20753
APPROVED
LORAIN CO.
MAP DEPT.
DATE 3-14-94
PAGE 16-00-001-A
BY CAROLYN
FRANCIS
VOID AFTER # 20753

16-00-001-101

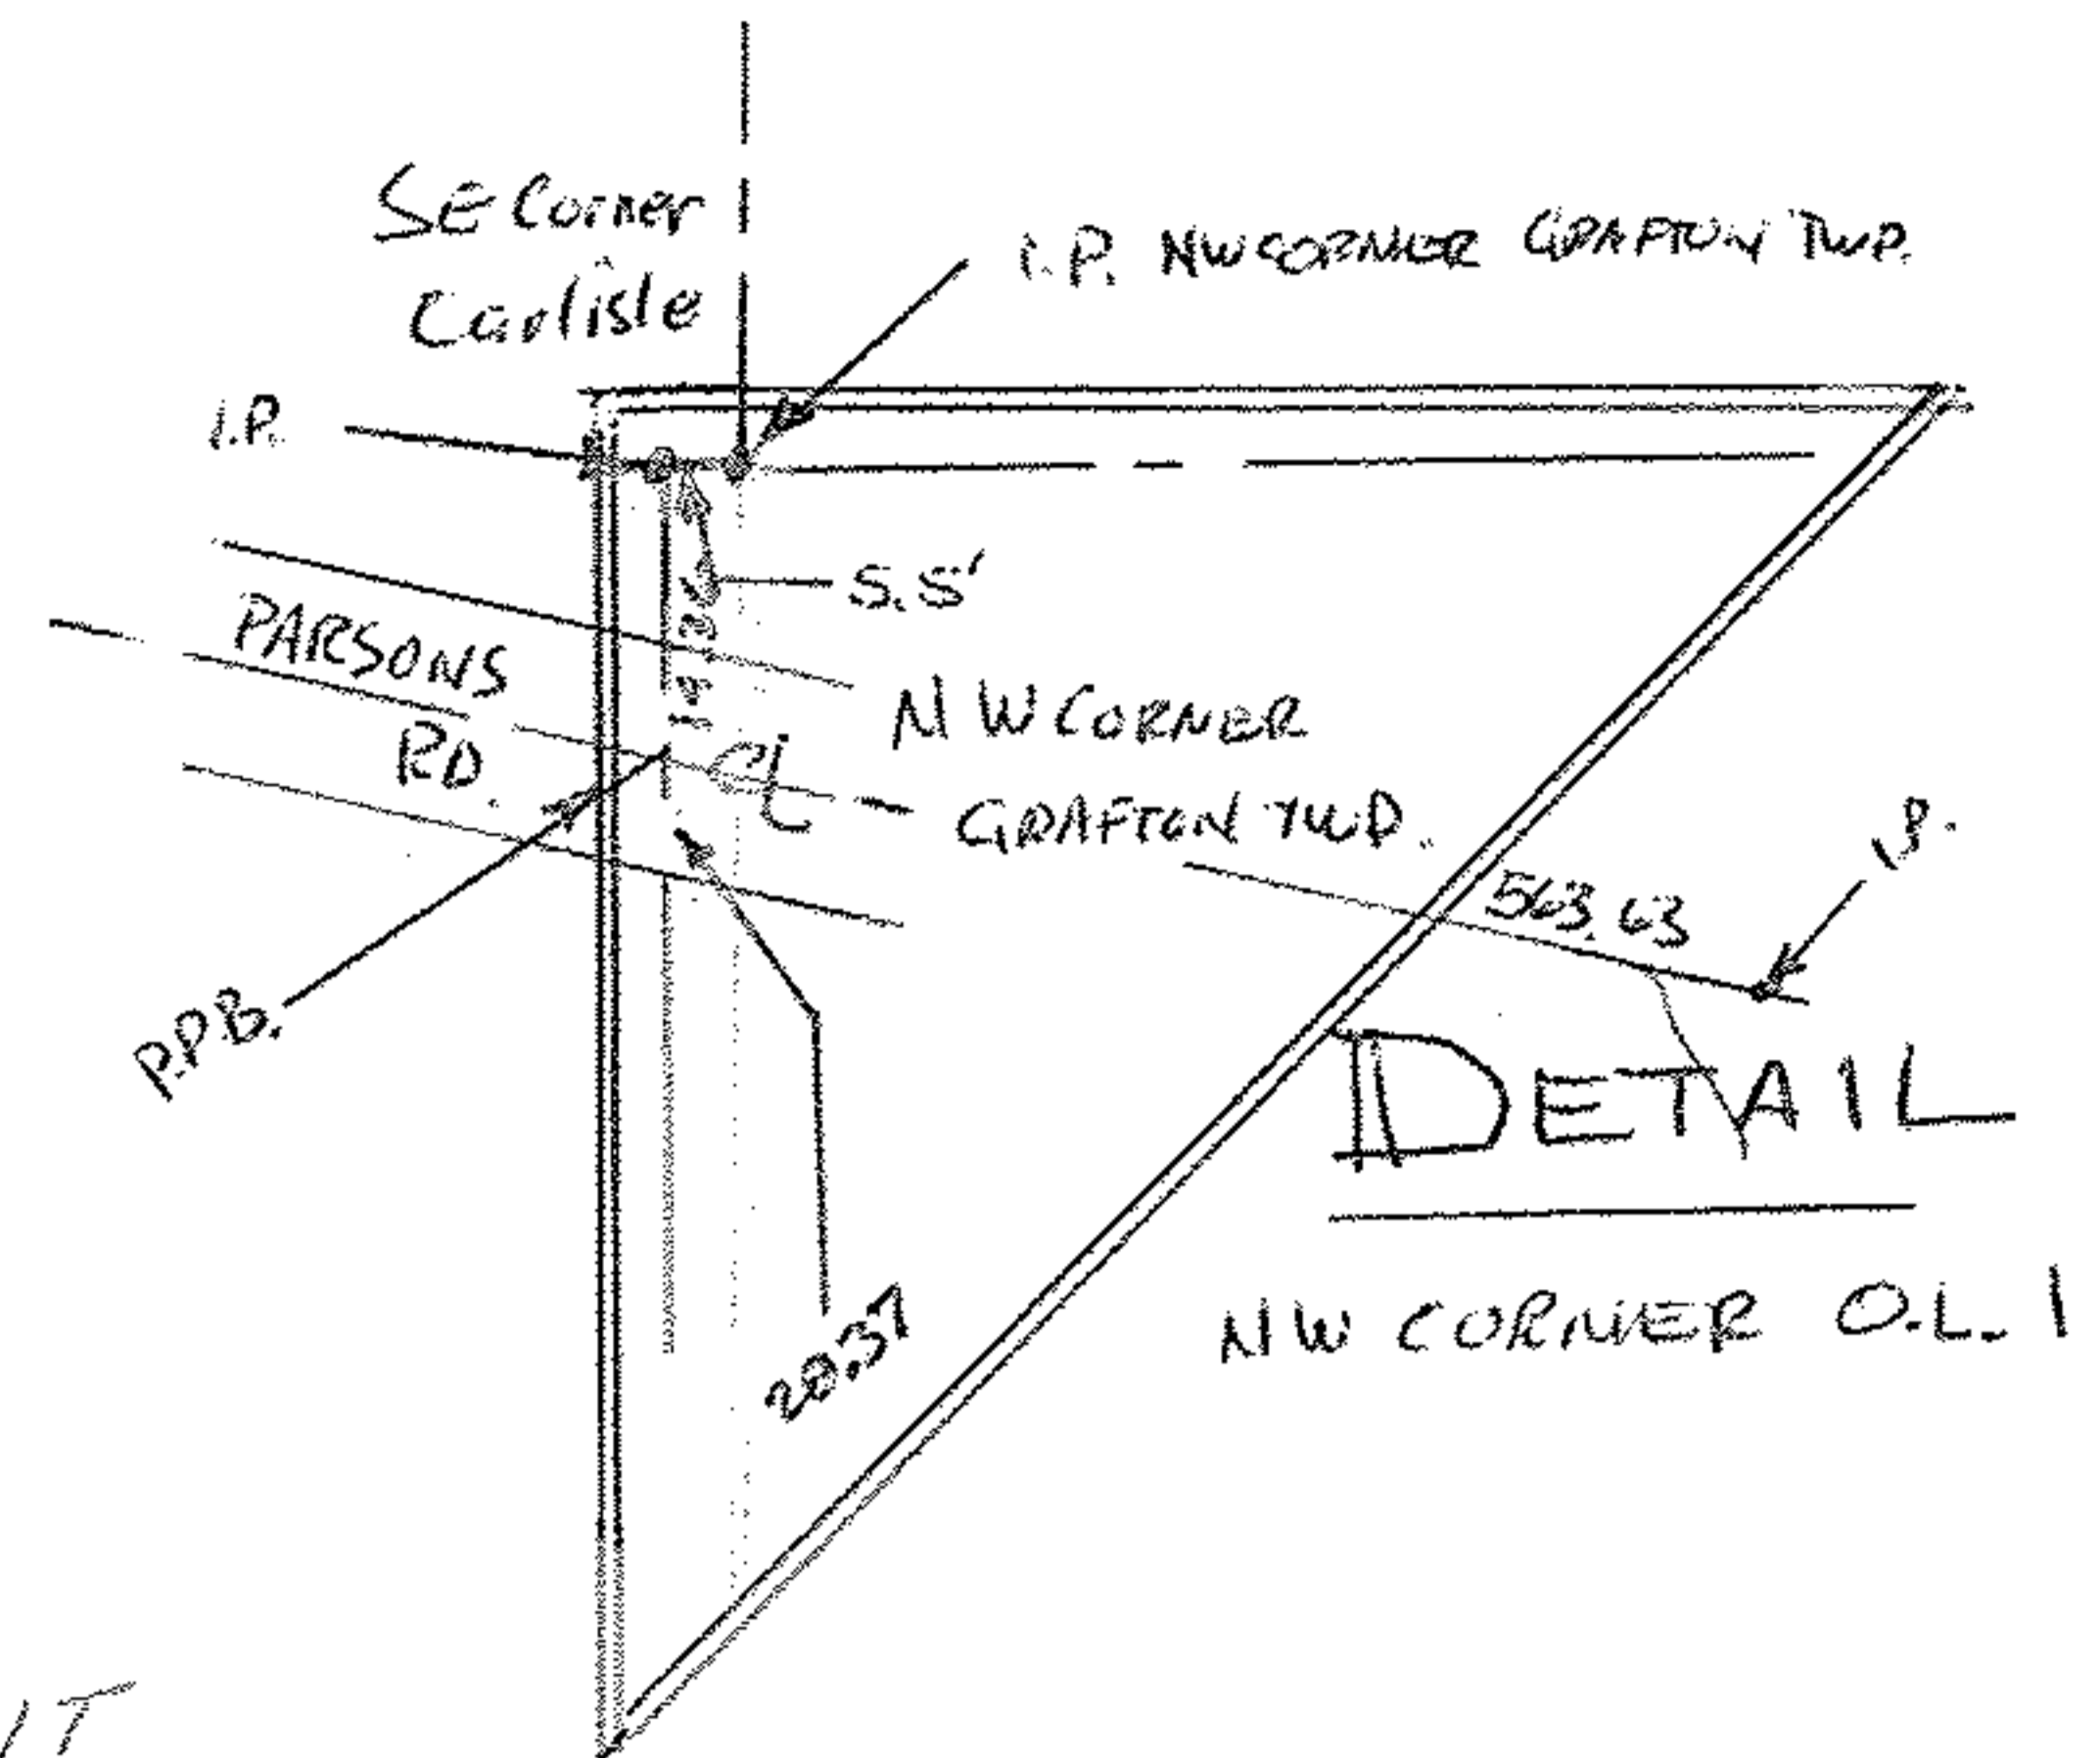
CURVE IN SPLIT
99.57A @ 4:10, 631, 730.

① 16-00-002-101-003	13.27A AC. CORR.	14.79A
② 16-00-019-101-001	1.50A AC. CORR.	1.09A
③ 16-00-002-101-001	15.62A COMB	
-002	0.62A COMB	
	16.24A AC. CORR.	16.56A

④ 16-00-001-101-001	42.62A
-018	28.11A
	70.73A
AC. SPLIT OUT	67.14A
	3.59A
AC. CORR. PER REFOUND REG SURVEYOR	7.71A

Comb.	
-001	15.62A
002	0.62A
Ac. Corr	16.24A
Grafton VILL.	16.56A

put in Break Line
